Delaware River Basin Commission Nitrogen Reduction Cost Estimation Study Addendum Technical Memorandum

Re: **Nitrogen Reduction Cost Estimation Study Addendum Technical Memorandum**

Kleinfelder, Inc. (Kleinfelder) is pleased to present this Nitrogen Reduction Cost Estimation Study Technical Memorandum as an addendum to the previously completed Nitrogen Reduction Cost Estimation Study Final Summary Report (Nitrogen Reduction Cost Study), DRBC Technical Report No. 2021-1. Recently, the Delaware River Basin Commission (DRBC) received a Docket Modification Application for the Delaware County Regional Water Quality Control Authority (DELCORA) Western Regional Treatment Plant (WRTP) to expand its permitted capacity from 50 mgd to 70 mgd.

Figure 6-17: DELCORA Plant Specific Total Present Cost Curve

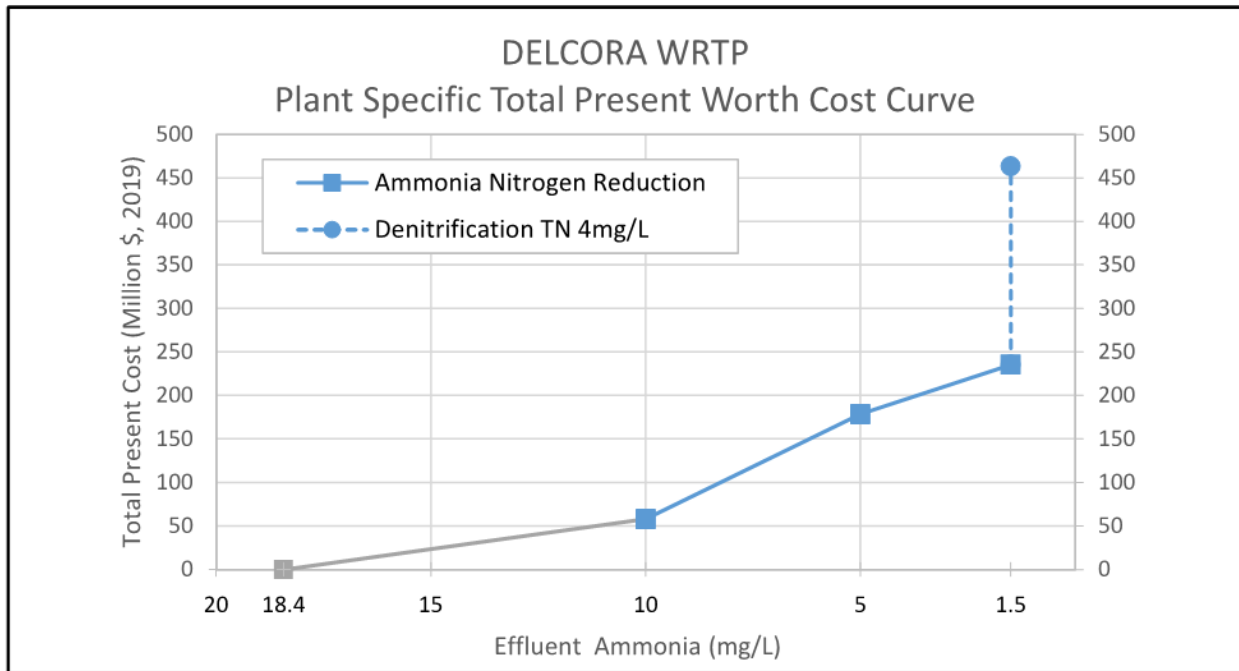
This section presents an update of Section 6.5.9 of the Nitrogen Reduction Cost Study. The DELCORA WRTP specific costs are summarized in Table 6-12. The corresponding cost curves, based on total present costs and total annualized costs, follow Table 6-12 as Figures 6-17 and 6-18, respectively.

The site-specific information, issues and factors that served as the basis for the plant specific costs presented in the DELCORA plant specific cost summary table are based upon the following factors:

- A requested permitted capacity of 70 mgd and corresponding maximum average monthly flow of 86 mgd.
- A maximum monthly summer average effluent ammonia concentration of 18.43 mg/L is approximately the same strength as the generic conventional activated sludge plant's maximum monthly summer average effluent ammonia concentration. As a result, and because the DELCORA WRTP is also currently operating at a mixed liquor suspended solids (MLSS) concentration of approximately 3,000 mg/L consistent with the MLSS concentration of the generic conventional activated sludge plant, the improvements for the DELCORA plant to achieve each effluent level will be the same as the generic conventional activated sludge plant, i.e., additional final clarifiers, increased process air capacity and return activated sludge (RAS) pumping improvements for the 10 mg/L effluent ammonia level and integrated fixed-film activated sludge (IFAS) for the 5 mg/L and 1.5 mg/l. effluent levels.

- Additional final clarifier surface area is required at a requested permitted capacity of 70 mgd.
- Groundwater will be encountered at a depth of approximately 10 ft. with dewatering required for major structures (assuming well point dewatering).

- Pile-supported foundations are required for all new structures.
- Sheet piling is required for all structure excavation.
- Reduction in productivity factor due to confined work area.
